Project Reading Metropolitan

LPA ref 182252

Additional Transport Note

Table 1: Response to residual RBC Highways Comments

Secure a S278/38 Agreement to upgrade the signalized pedestrian crossing located on Caversham Road adjacent to the site south of Northfield Road to a toucan crossing as illustrated on drawing ref 23061101-SDG-HGN-100-DR-D-01011.

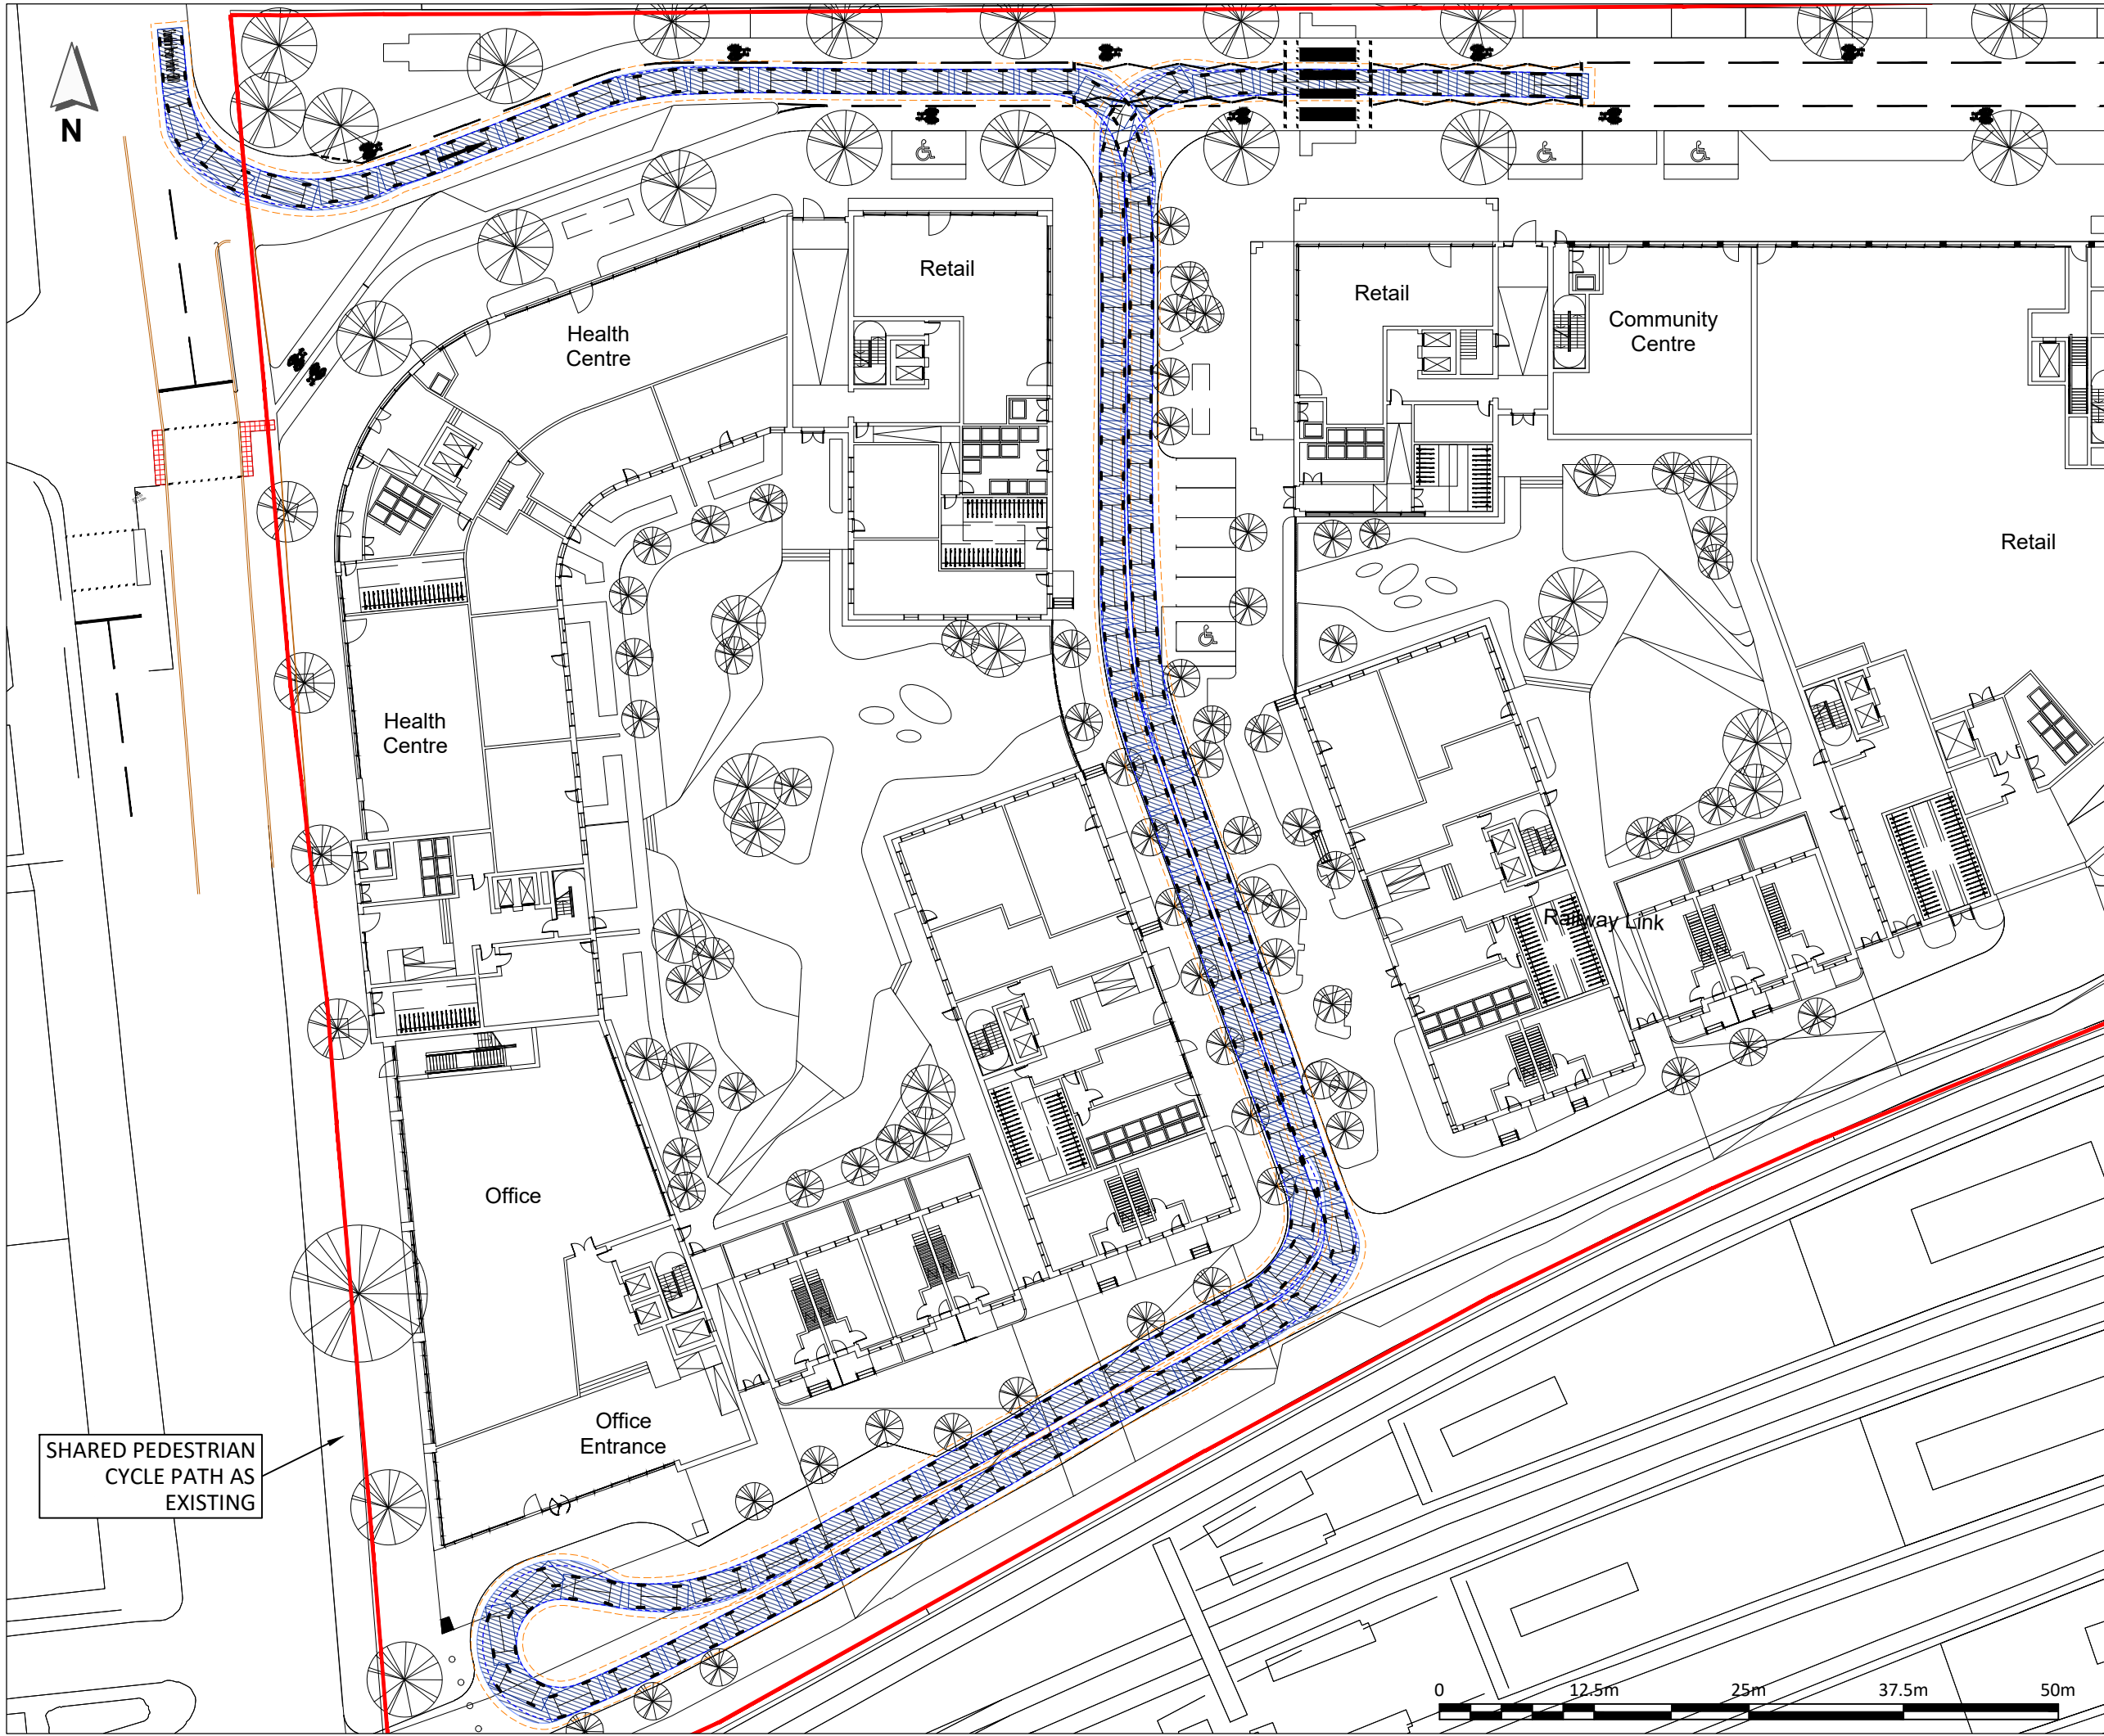
S106	Secure a S278/38 Agreement to upgrade the signalized pedestrian crossing located on Caversham Road adjacent to the site south of Northfield Road to a toucan crossing as illustrated on drawing ref 23061101-SDG-HGN-100-DR-D-01011. £5,000 towards a traffic regulation order for alterations to the parking restrictions along the Caversham Road frontage of the site. £300,000 towards upgrade / improve the underpass so that it is suitable for cyclists. To provide and fund the 2 car club spaces identified on the submitted plans.	This is agreed by the applicant. However, please use Drawing 23061101-SDG-HGN-100-DR-D-01012 for the purposes of the agreement. This has identical proposals within the public highway to Drawing 23061101-SDG-HGN-100-DR-D-01011 but updates the highway layout within the site boundary. This is agreed by the applicant. This is not agreed. Further detail is requested from RBC on the nature and extent of works proposed to facilitate further discussions. This is agreed.

Drawing Title: GROUND FLOOR SWEPT PATH ANALYSIS (SHEET 3 OF 12)

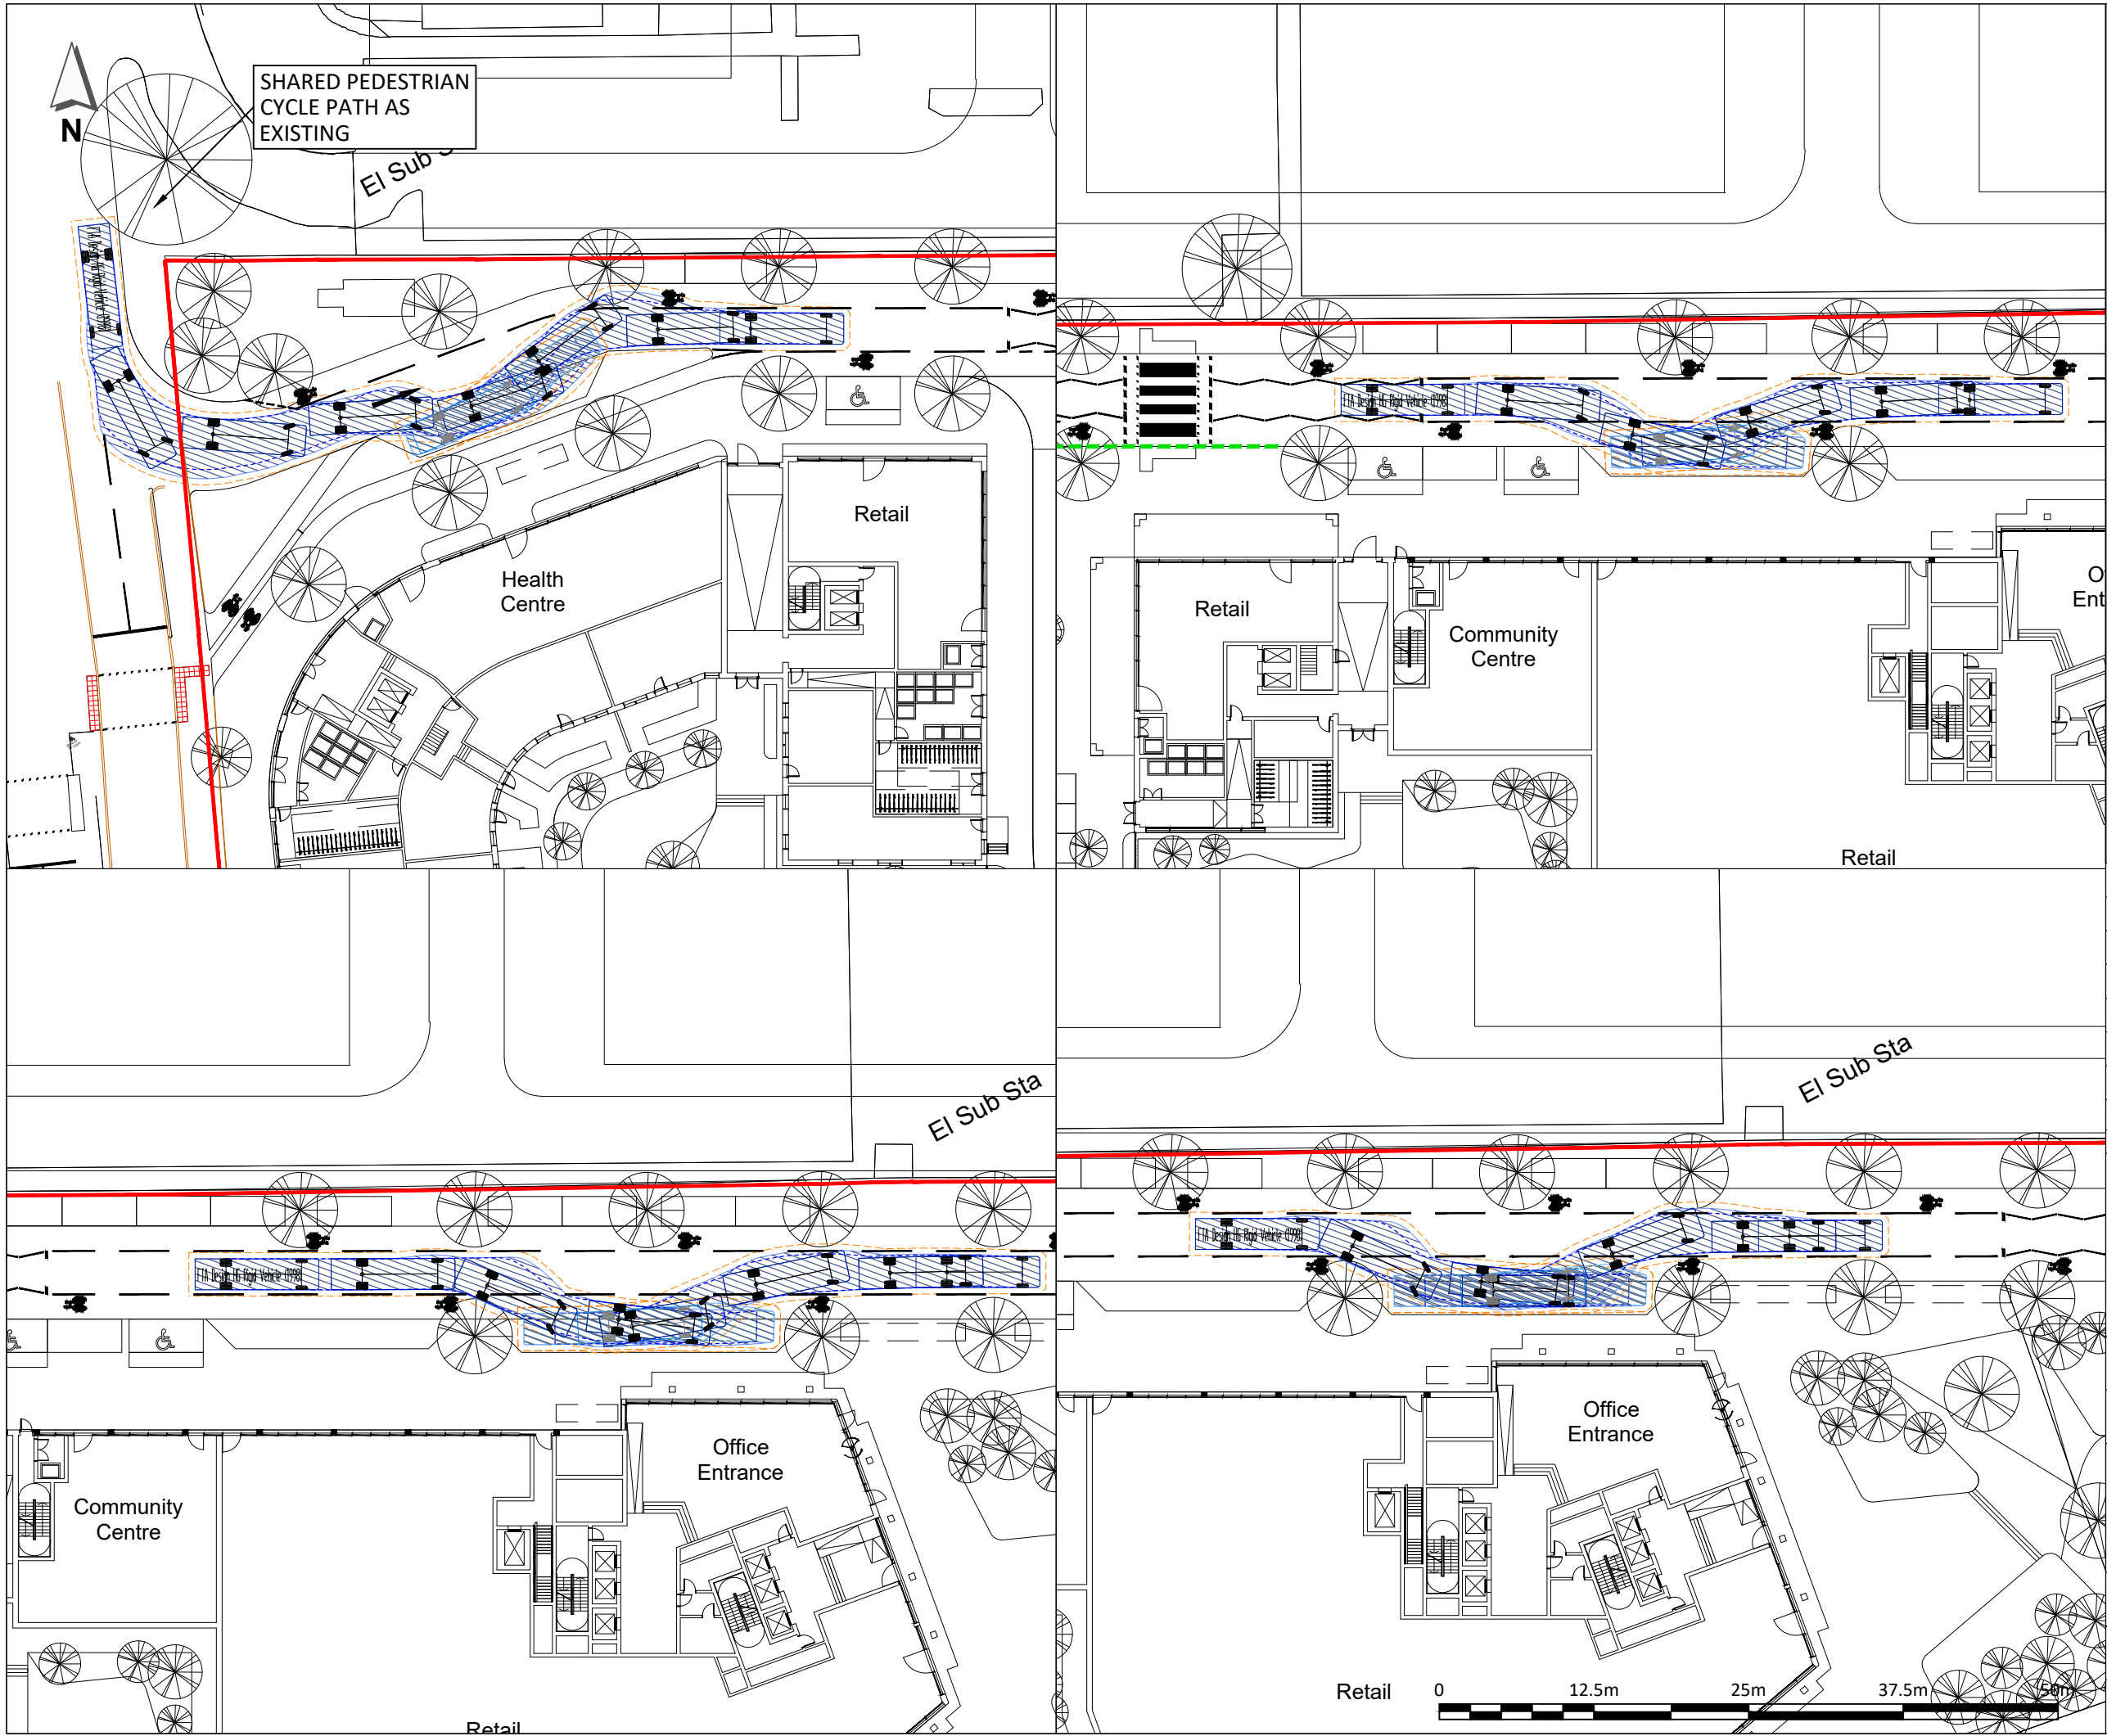
Topic	RBC Comment	Response
	the commencement of the advisory cycle lane, this should also be addressed by way of amended plans. The applicant has stated that this has been addressed by way of amended plans but this is still an outstanding issue. Providing a dedicated cycle route through the site would comply with the requirements of the NPPF which states that development should give priority first to pedestrian and cycle movements, both within the scheme and with neighbouring areas. Revised drawings should therefore be provided that include the provision of a dedicated east / west cycle lane that are to the required standards.	the detailed design of the on-site highway layout, to ensure the requirements identified by RBC are fully taken into account and to ensure full co-ordination with the adjacent S278 works on Caversham Road.
Site Access	An existing access currently exists to the south west corner of the site and this is to be retained as an access to network rail but will be restricted access through bollard control. It has been confirmed that access to this road from Caversham Road will only be provided to Network Rail vehicles as and when required. A tracking diagram has also been provided demonstrating that vehicles with a length of up to 8m are able to wait for entry without obstructing pedestrian movement. Furthermore, vehicles with a length of up to 10m can wait for entry without obstructing vehicles using the nearside southbound lane on Caversham Road. It also states that the applicant does not expect vehicles above 10m to use the Network Rail access point. However, as previously stated it must be confirmed by Network Rail what type of vehicle would use this access this has still not been provided to the Highway Authority it has only been stated by the applicant that this is the case. In addition, the submitted drawings still only identify an 8m long 7.5t box van, as has previously been stated the layout should ensure that no vehicles obstruct the footway or carriageway. Historically no gate existed at this access point and therefore no obstruction should be introduced which would cause a hazard to pedestrians and be detrimental to Highway Safety.	Network Rail have indicated that the largest vehicle expected to use this access would be an 8m 7.5T box van
